Attachment 111
UNITED STATES DEPARTMENT OF AGRICULTURE
FOREST SERVICE

Manti-LaSal National Forest
599 West Price River Drive
Price, Utah 84501

RE: Price River Coal Company's
Technical Analysis
Response and Approval
Crandall Canyon Modification
ACT/007/004
Carbon County, Utan

Price River Coal Company's Crandall Canyon Modification to the Price River Mining Complex

PROPOSED PONDS 012 A & B

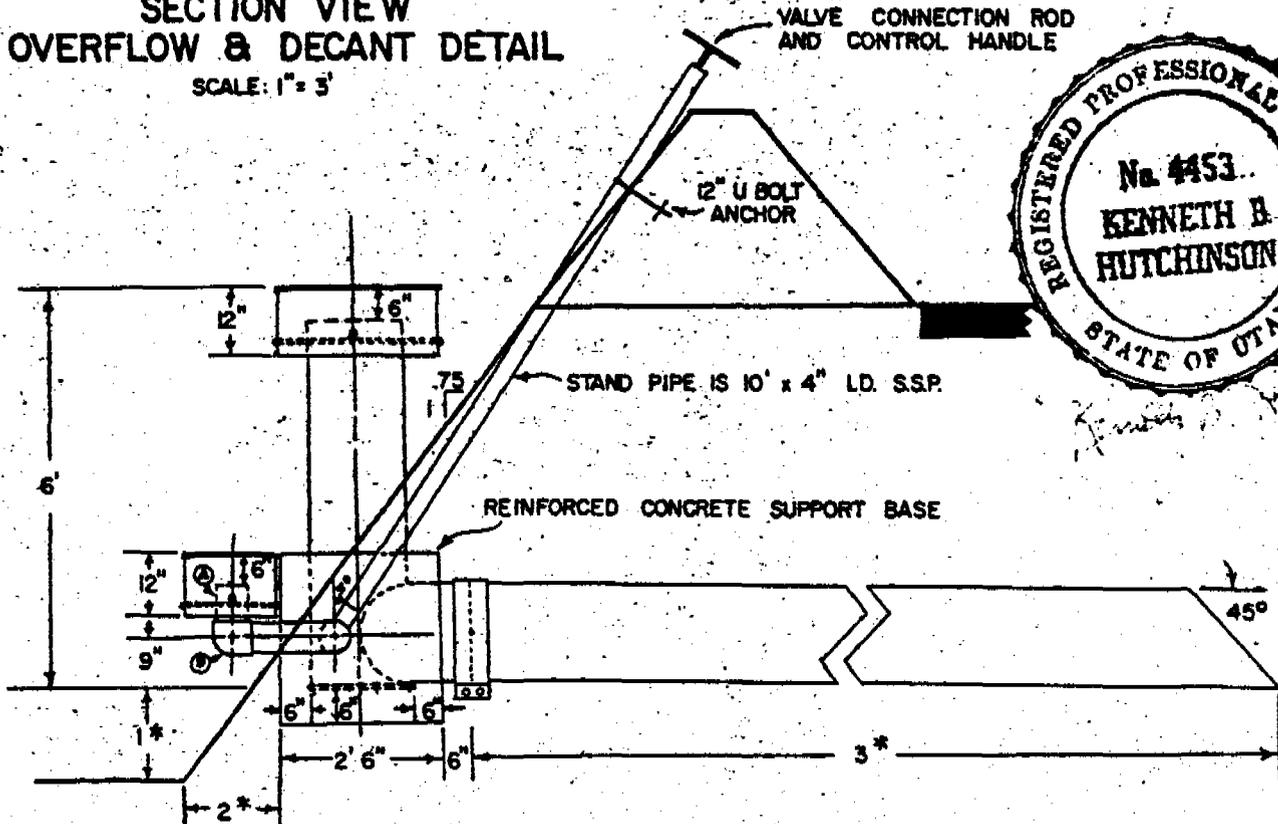
We have reviewed the plans and information for the Price River Coal Castlegate preparation plant sediment ponds. Drawings CGE 101 through CGE 104-3, A1-100 and information submitted December 10, 1982, February 9 and March 7, 1983 were reviewed.
